**NORTH WALES WINDFARM OVERHEAD LINES EXAMINATION
DEADLINE 3 SUBMISSION – DENBIGHSHIRE COUNTY COUNCIL**

ATTACHMENT 1 OF 4

IN RELATION TO LANDSCAPE AND VISUAL IMPACT HEARING, 30TH SEPTEMBER

Comparison between pole sizes

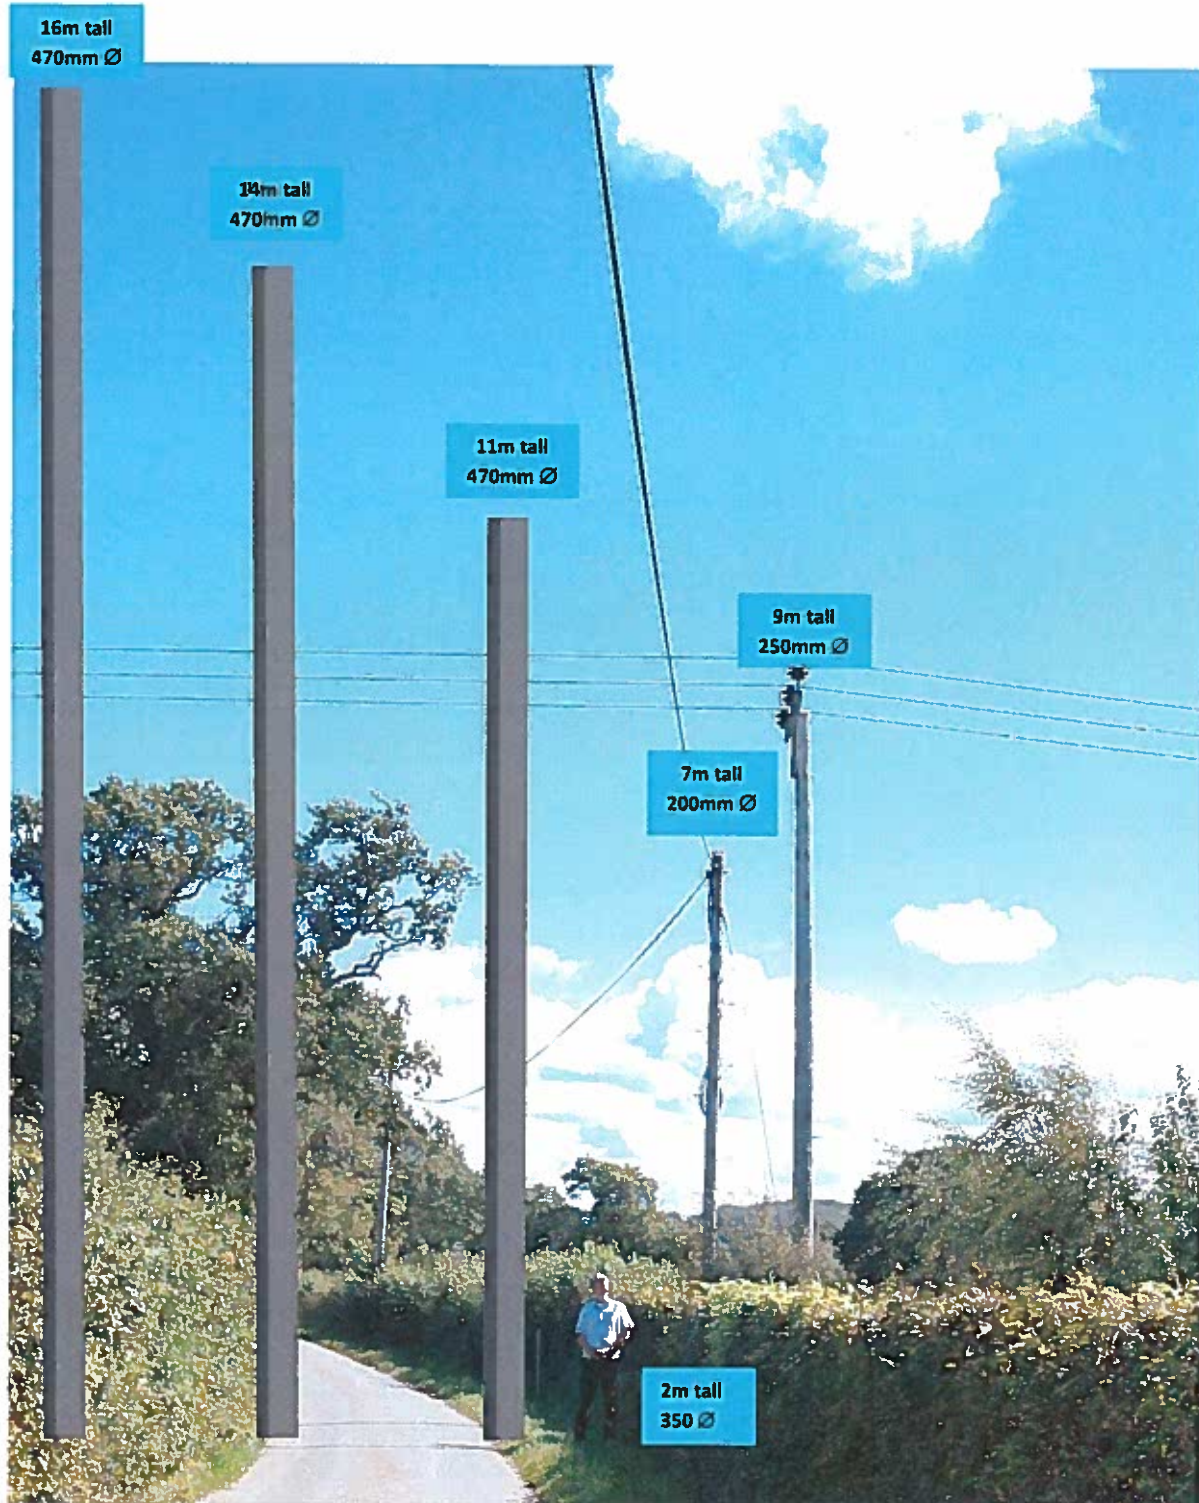
SPManweb propose using 11.1 to 16.6 metres tall pairs of 470mm in diameter (18.8 inch) wooden poles set 3 metres (10 ft) apart. These poles will be taller than many of the local trees which tend to be modest in stature. The Council considers that whilst these will be made of wood, they would be of sufficient height and diameter to be intrusive forms in the landscape and would cause adverse visual impacts on residential properties and public space.

A photograph illustrating the typical telecoms pole and electricity pole with superimposed poles of the kind proposed for the North Wales connections was presented as evidence by Andrew Sumner during the examination on the 30th September. This photograph (entitled **Comparison between pole sizes**) is submitted with this summary.
